Comment (145.2.5.7, P142, L9)

In D3.1 we add the following functionality, and after simulating some parts and analyzing the changes we did, we found some errors in state machine and variable definitions that need to be corrected.

2.1 Make the following changes to the state machine per the following drawing for the primary and secondary per the example done below for the primary.

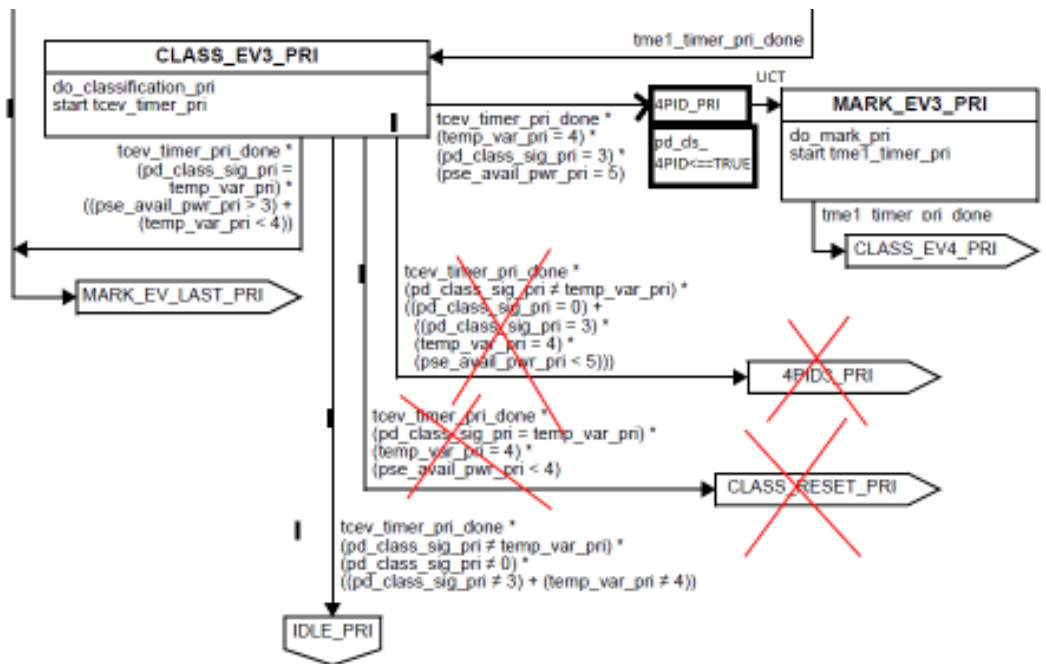
- 1) If option_class_probe is set, state machine will either go to IDLE_PRI or to CLASS_RESET_PRI and from there eventually to IDLE_PRI instead of continuing towards powering the port, which is an error (The intent was to allow powering while doing only single long class event and not twice. **Now it will not power at all**).

The end result is no matter what we do when available power<4 we can't power!

- 2) In the definition of option_class_probe it says that this variable is used only when pse_avail_pwr_pri<4. As a result, it is not possible that we will have exit from CLASS_PROBE_PRI to IDLE_PRI with a condition pse_avail_pwr_pri>=4 since it will never happen in this route....!!!!. As a result, in both exits from CLASS_PROBE_PRI, we need to remove the parameter pse_avail_pwr_pri and replace it with another new parameter.

Annex A - Problems related to option_class probe:

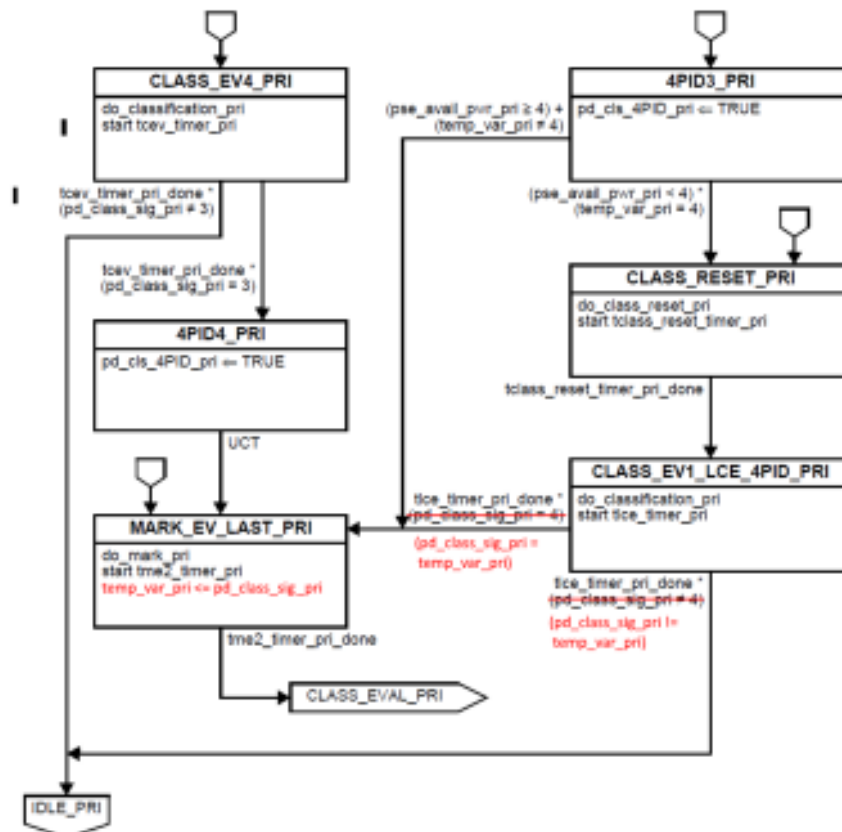
1. We need to different option_class probe variables for primary and secondary since each pair may need different power levels.
2. In option_class probe, the text defines that class_probe is used for pse_avail_pwr<4 but in the state machine there is exit from CLASS_PROBE_PRI to IDLE_PRI if pse_avail_pwr>=4 which is impossible.
3. The text for option_class probe for single_signature should be different than the text needed for option_class_probe_pri.
